SUBJECT: Quad Cities Nuclear Power Station, Unit 1 (TAC 66197)

AMENDMENT TO FACILITY OPERATING LICENSE

Amendment No. 103  
License No. DPR-29

ATTACHMENT TO LICENSE AMENDMENT NO. 103

Figure 2.1-1

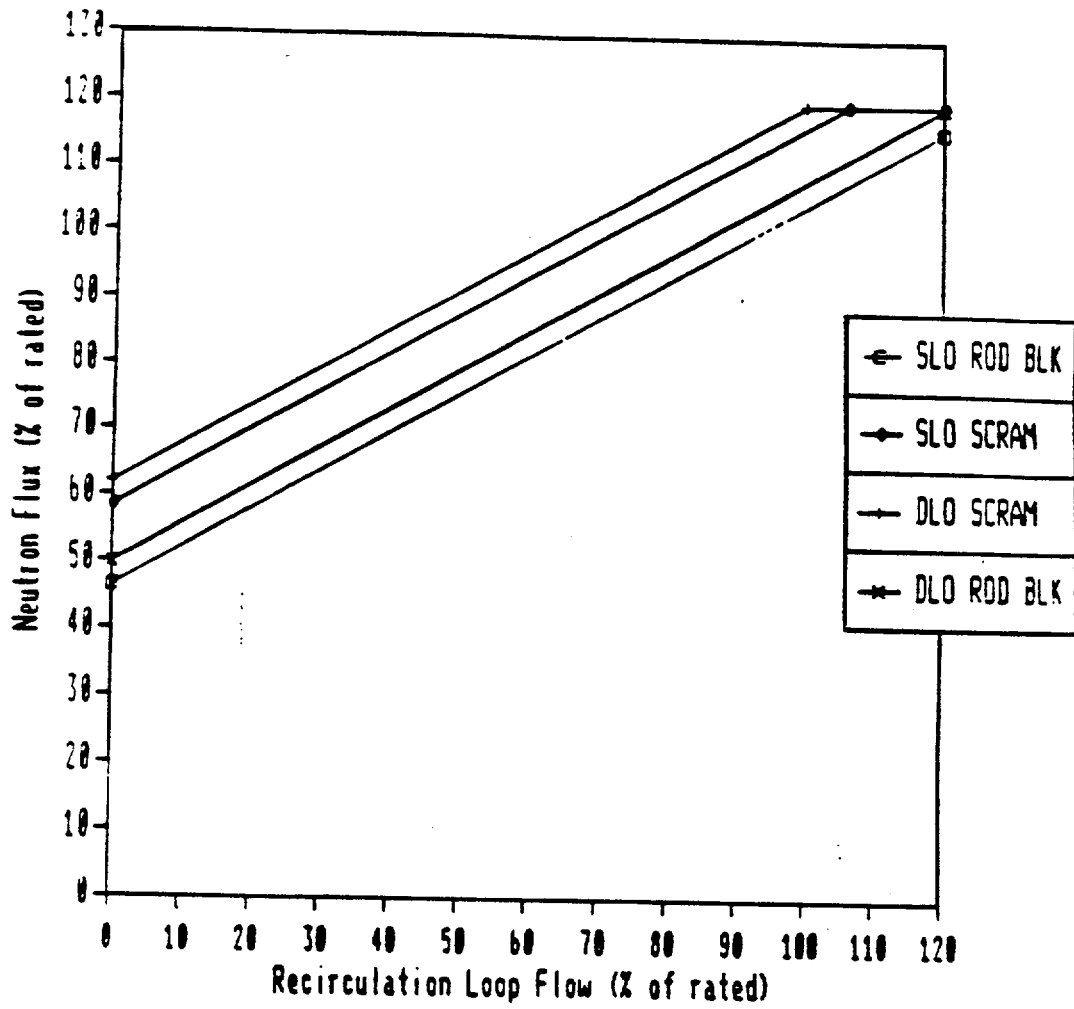
Appropriate lines giving APRM scram and rod block setpoint for SLO are added.

FIGURE 2.1-3  
(SCHEMATIC)  
APRM FLOW BIAS SCRAM RELATIONSHIP  
TO NORMAL OPERATING CONDITIONS

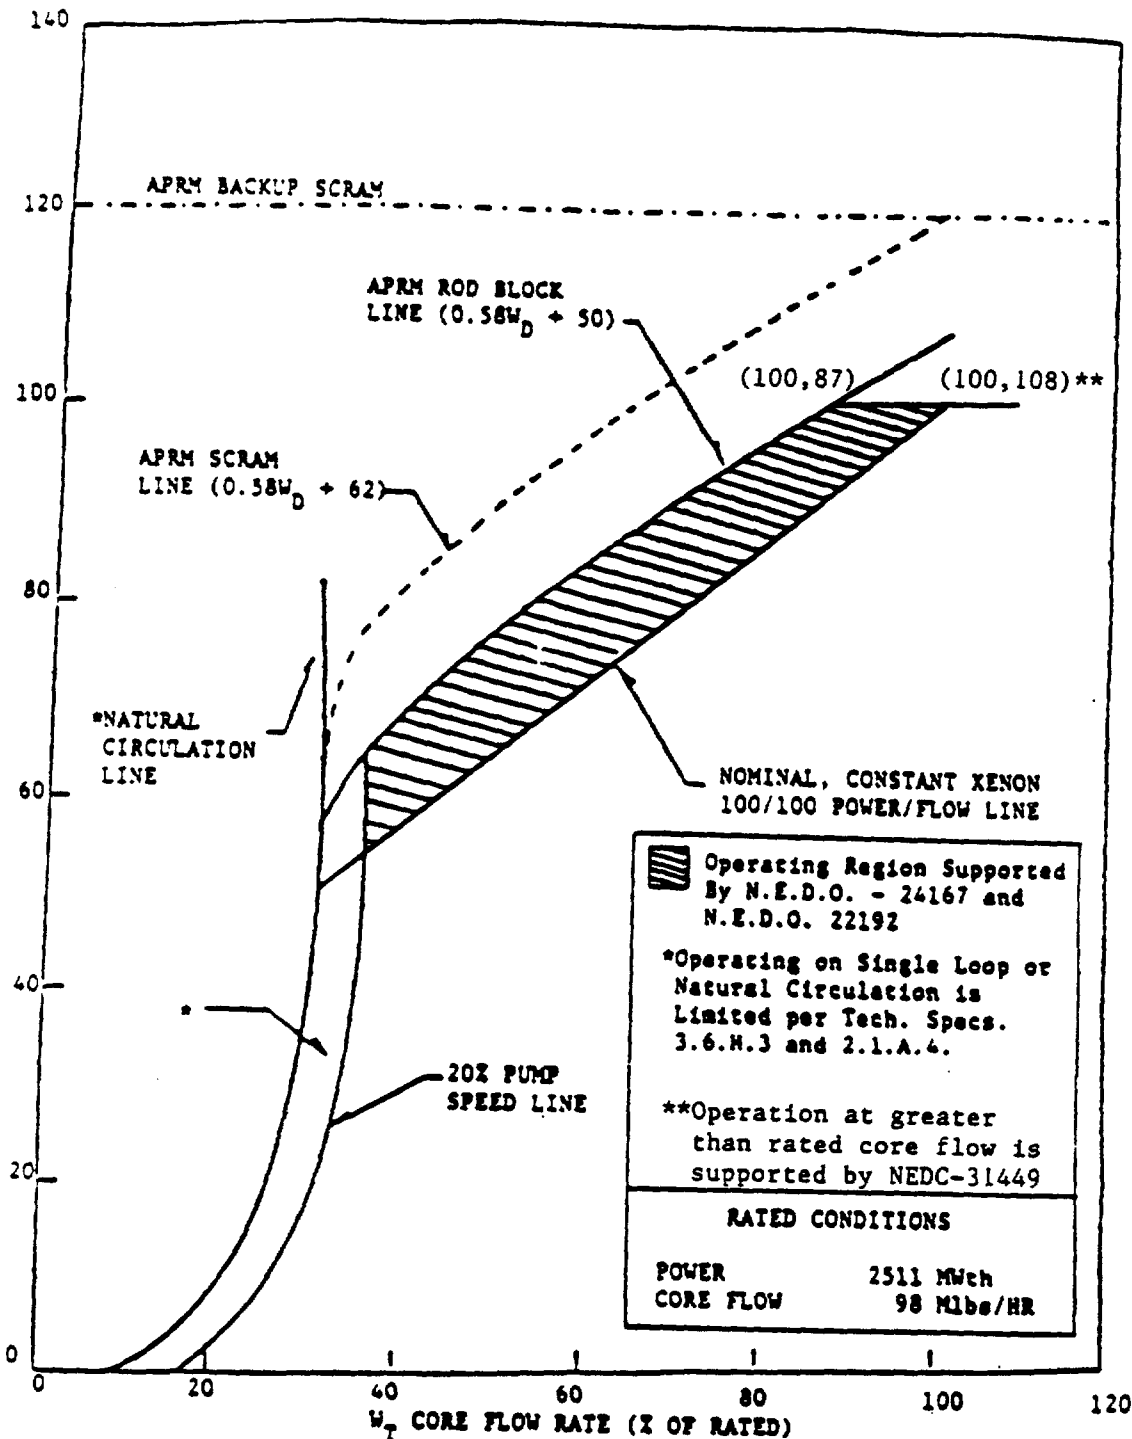
The approved ICF region is added to the power-flow map.

Figure 3.5-1 (Sheet 1 of 5)

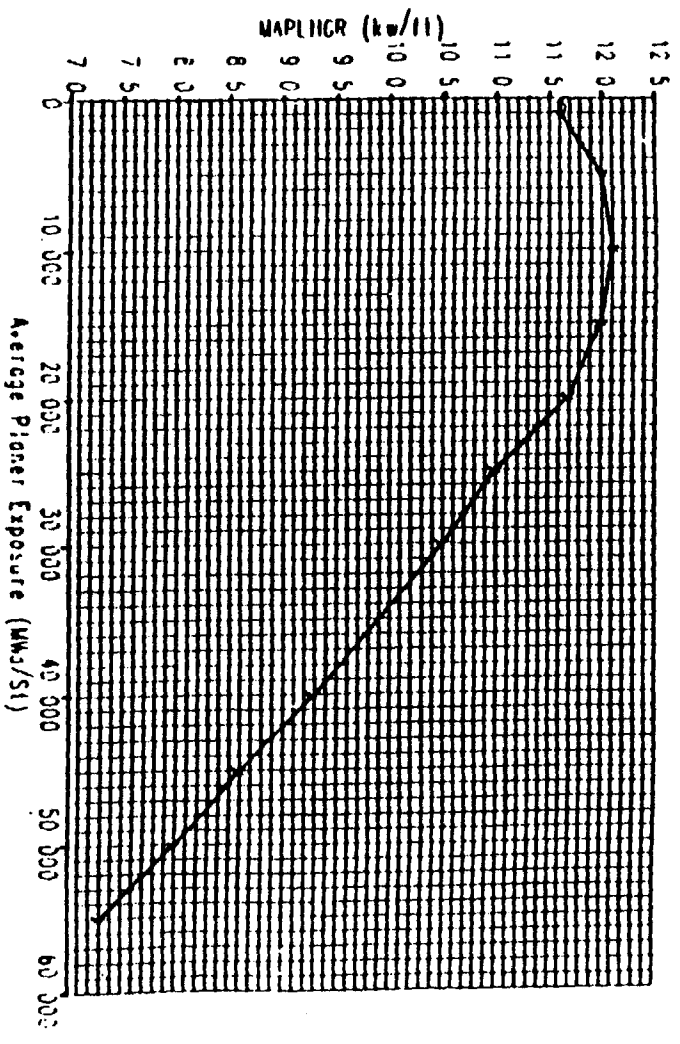
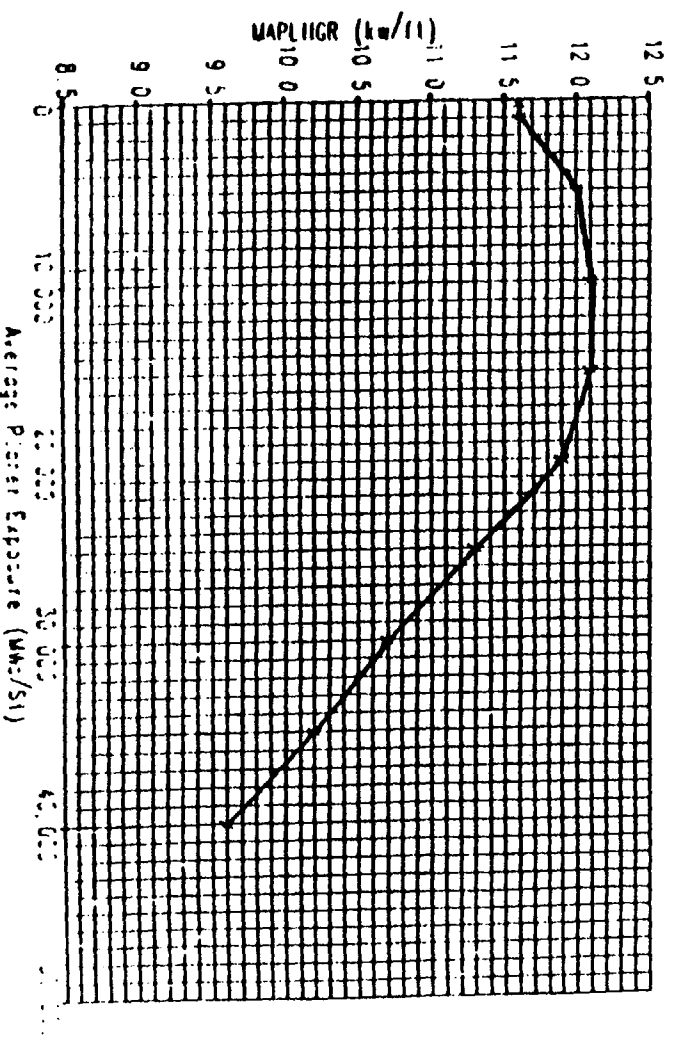
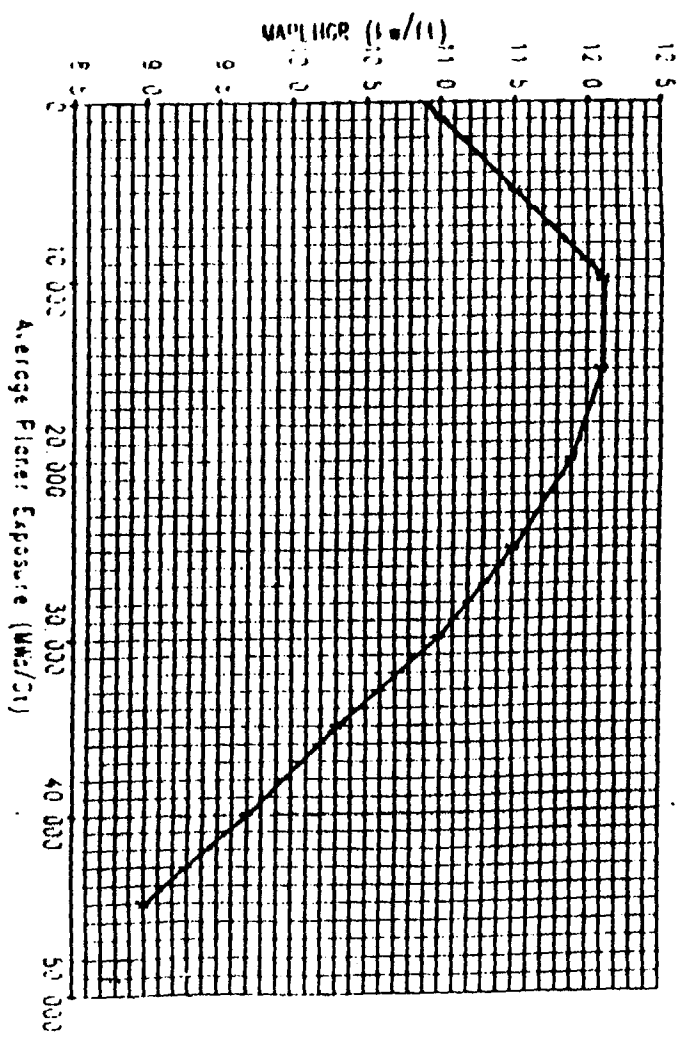
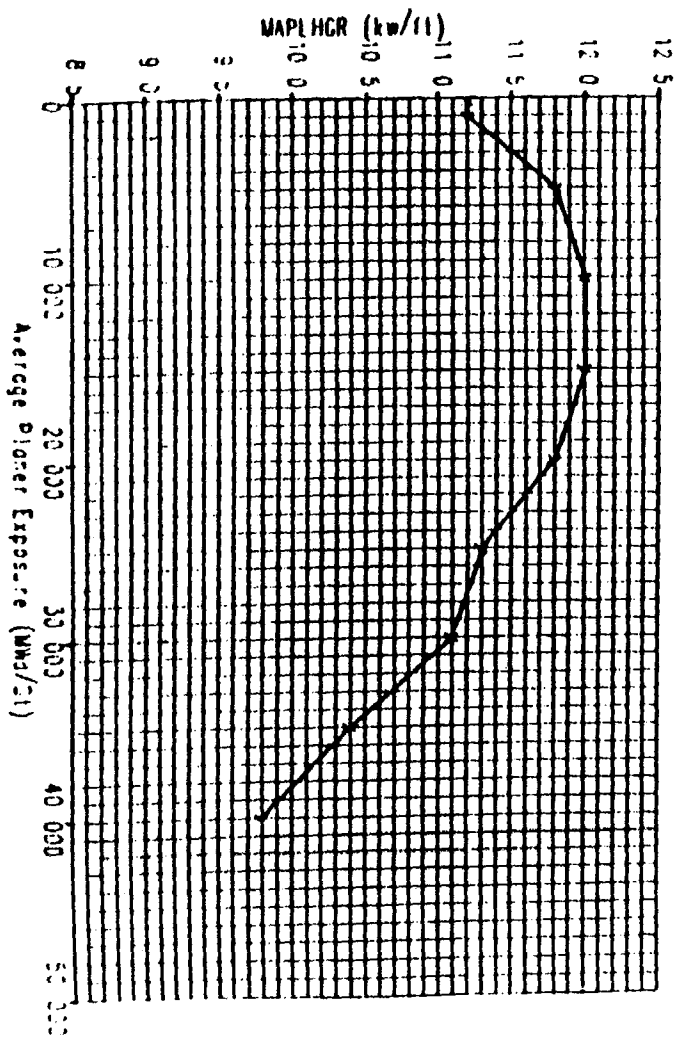
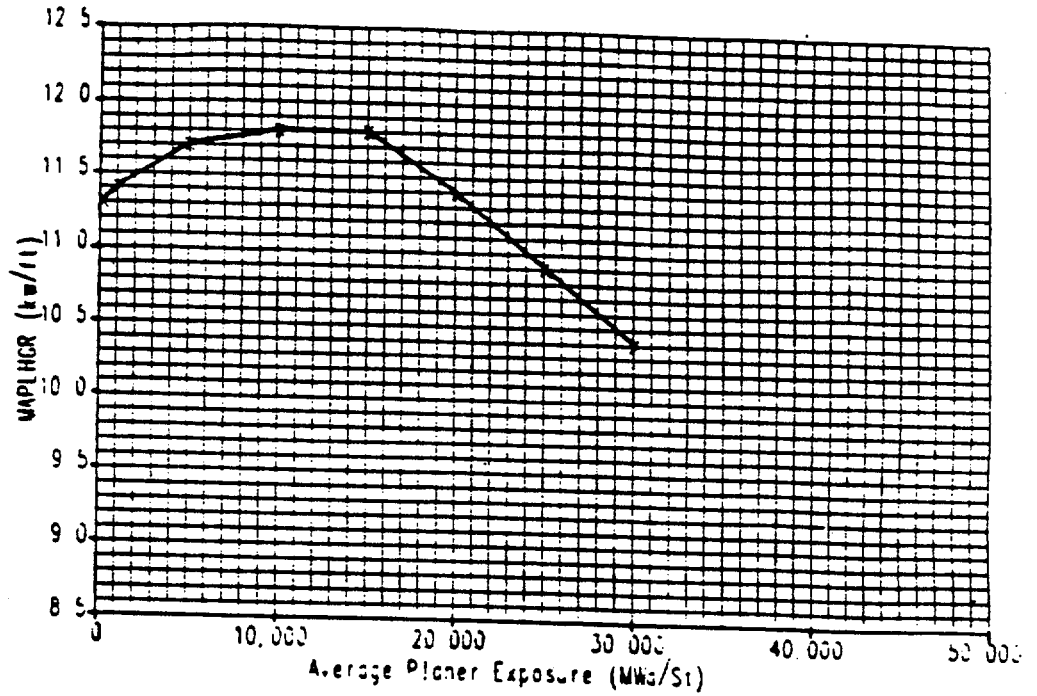
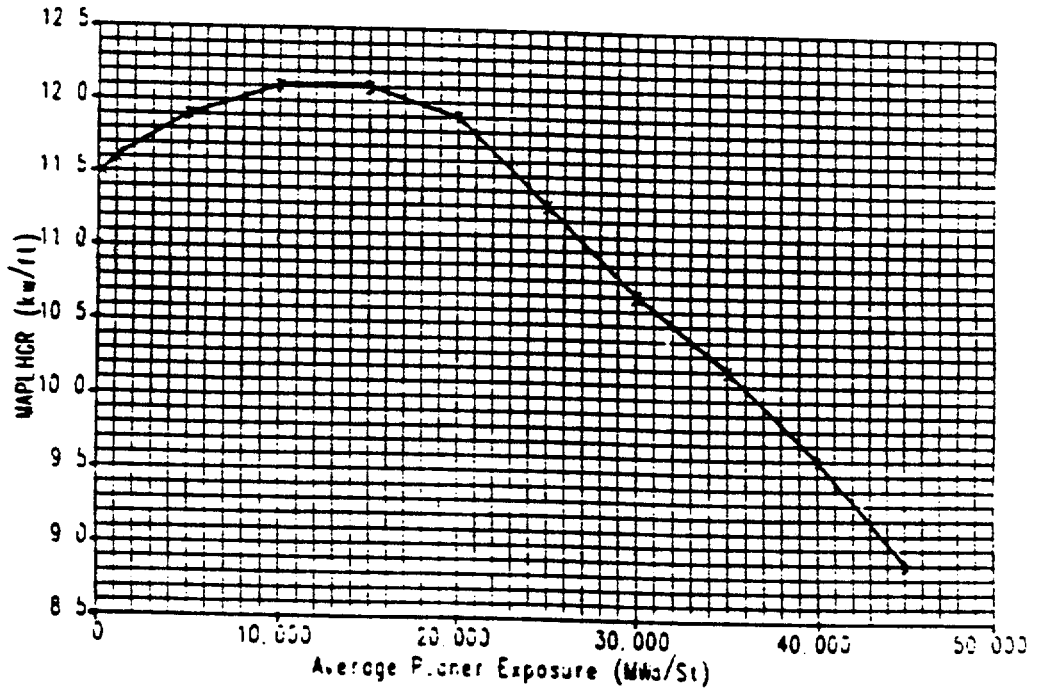
Figure 3.5-1 (Sheets 1-5)
